SUBJECT: LICENSE AMENDMENT NO. 142- CYCLE 9 RELOAD (TAC 63568)

AMENDMENT TO FACILITY OPERATING LICENSE

Amendment No. 142
License No. DPR-49

SAFETY EVALUATION BY THE OFFICE OF NUCLEAR REACTOR REGULATION

POWER-DEPENDENT MINIMUM CRITICAL
POWER RATIO MULTIPLIER (K_p)
FIGURE 3.12-2

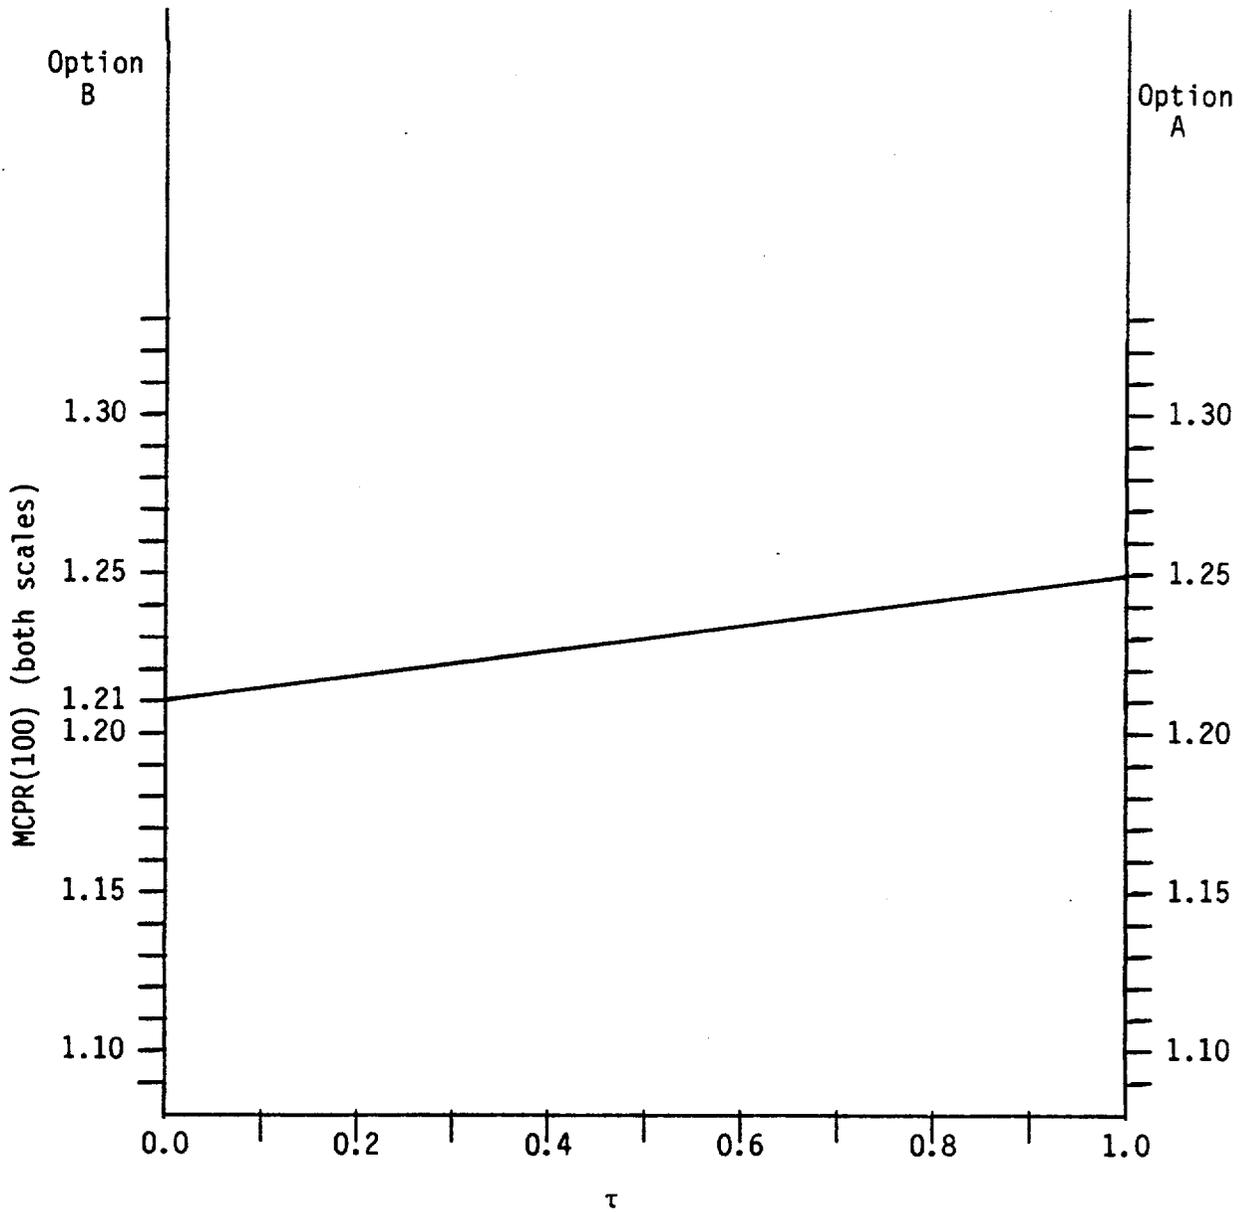
For operation above 30% of rated thermal power, the core power-dependent MCPR operating limit is the rated power MCPR [$MCPR(100)$], multiplied by the factor given in Figure 3.12-2, i.e., K_p . For operation below 30% of rated thermal power, where the direct scrams on turbine control valve fast closure and turbine stop valve closures are bypassed, absolute MCPR limits are established. This limit is taken directly from

Figure 3.12-2. This limit protects the fuel from abnormal operating transients, including localized events, such as a rod withdrawal error, other than those resulting from inadvertent core flow increases, which are covered by the flow-dependent MCPR limits. This power-dependent MCPR limit was developed based upon bounding analyses for the most limiting transient at the given core power level. Further information on the MCPR operating limits for off-rated conditions is presented in Reference 5.

DUANE ARNOLD ENERGY CENTER IOWA ELECTRIC LIGHT AND POWER COMPANY TECHNICAL SPECIFICATIONS
LIMITING AVERAGE PLANAR LINEAR HEAT GENERATION RATE AS A FUNCTION OF PLANAR AVERAGE EXPOSURE
FUEL TYPE: BD303A
FIGURE 3.12-4

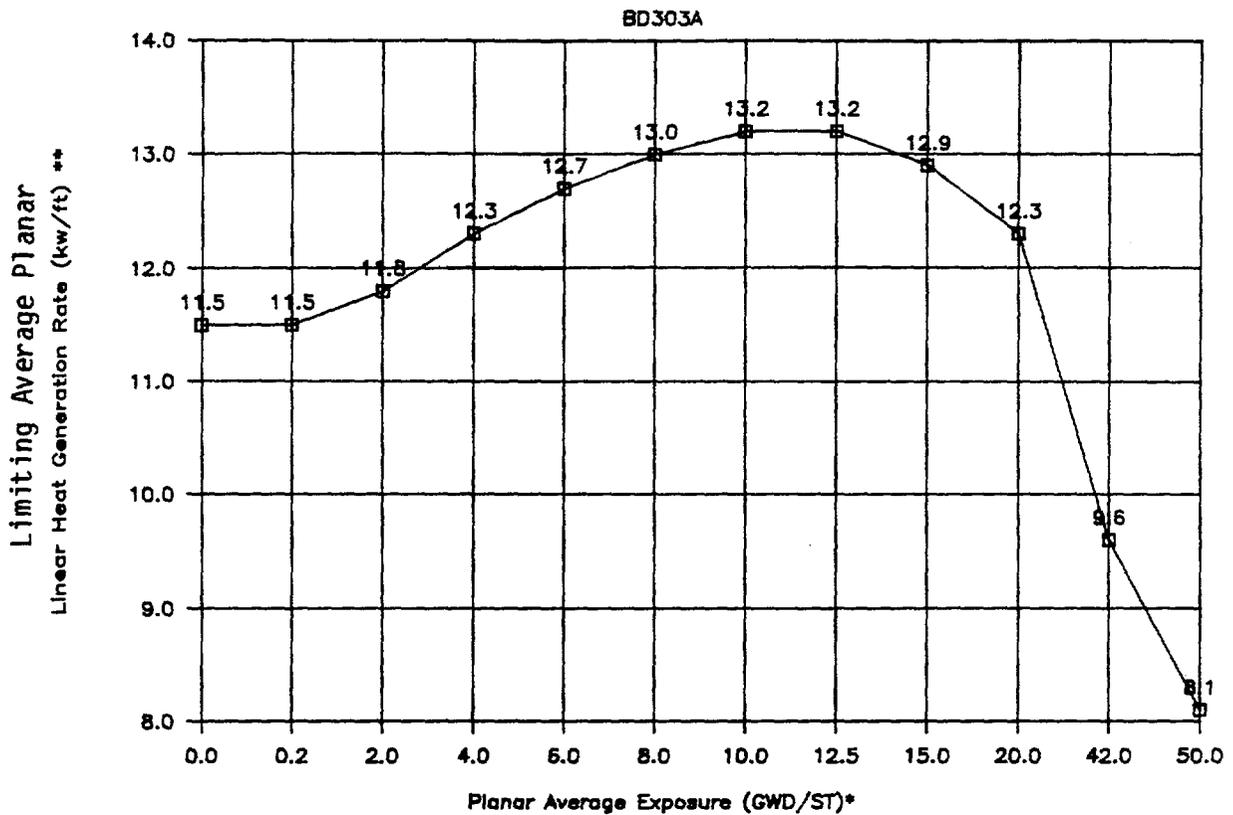
The MAPLHGR limits specified in the proposed TS changes are less than or equal to the bounding MAPLHGR used in the SAFER/GESTR-LOCA analysis (Ref. 4) and are, therefore, acceptable.

The TS changes proposed by the licensee reflect the new fuel for Cycle 9. These changes include the LHGR limit, MCPR operating limit and the MAPLHGR curve for the GE8x8E fuel. These proposed changes are acceptable since they are based upon approved analytical methods as discussed above.

FLOW-DEPENDENT MAXIMUM AVERAGE PLANAR
LINEAR HEAT GENERATION RATE (MAPLHGR)
MULTIPLIER (MAPFAC_F)
FIGURE 3.12-10

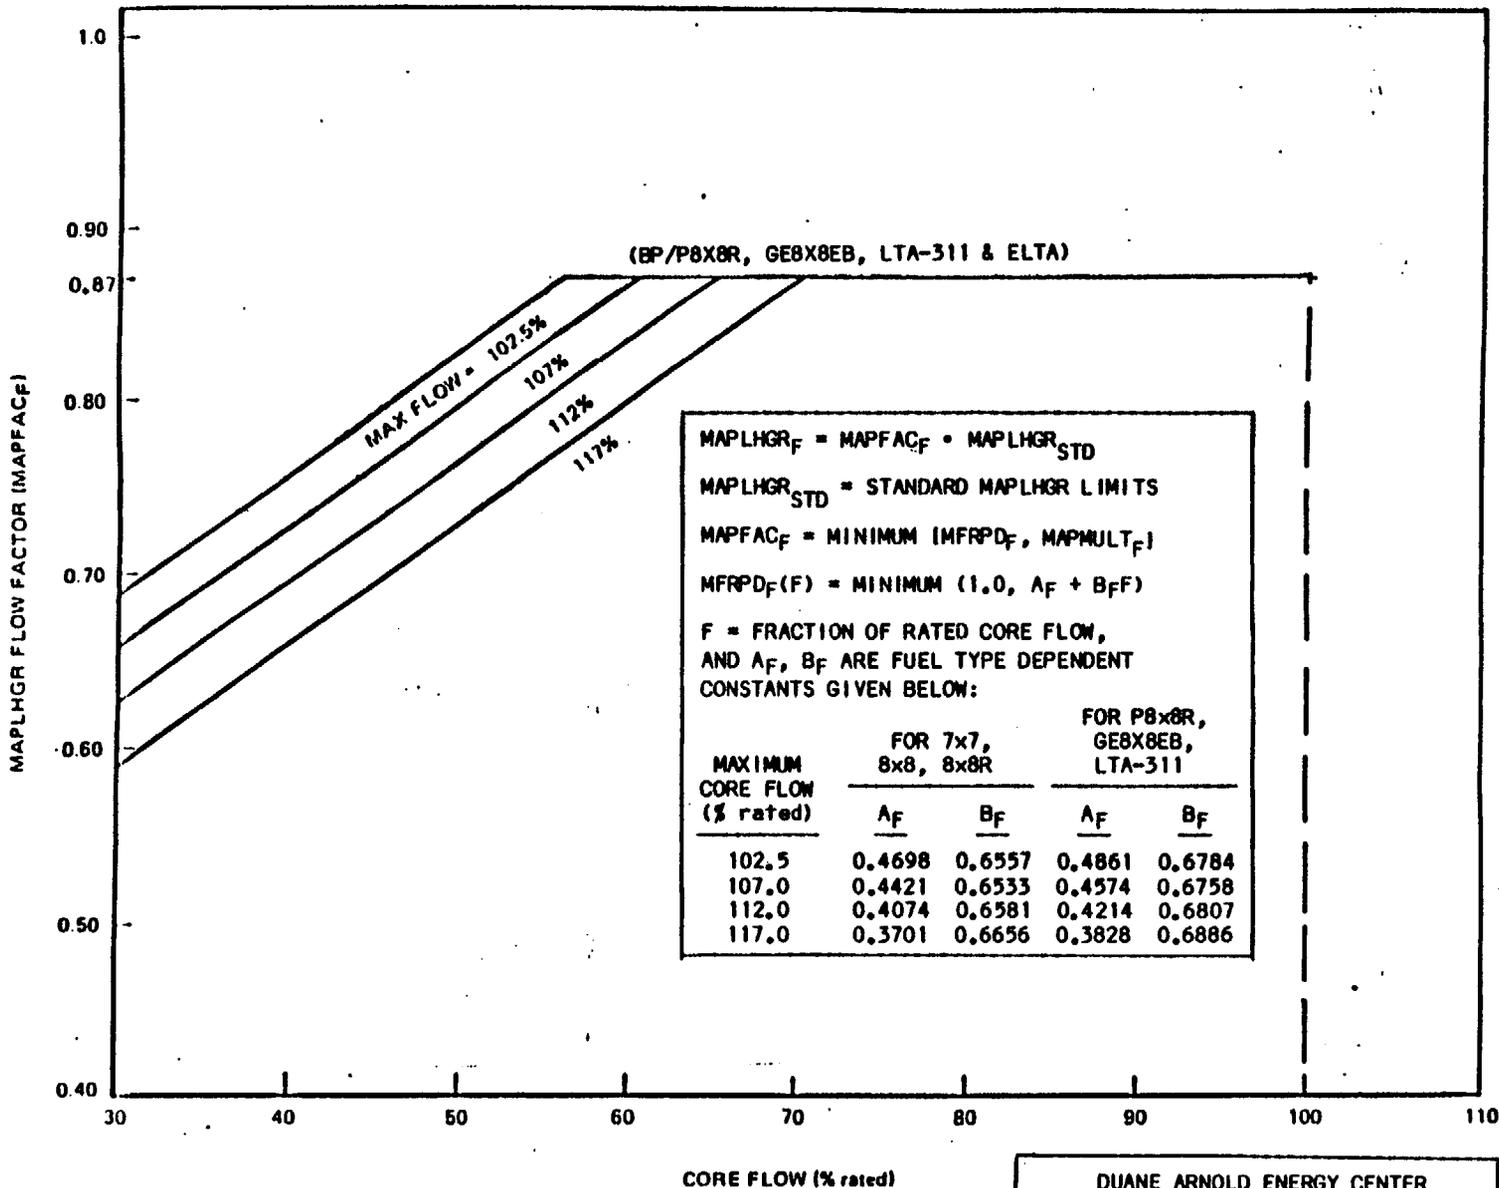
The flow-dependent correction factor (Figure 3.12-10) applied to the MAPLHGR limits at rated conditions assures that (1) the 10CFR50.46 limit would not be exceeded during a LOCA initiated from less than rated core flow conditions and (2) the fuel thermal-mechanical design criteria would be met during abnormal operating transients initiated from less than rated core flow conditions (Reference 5).
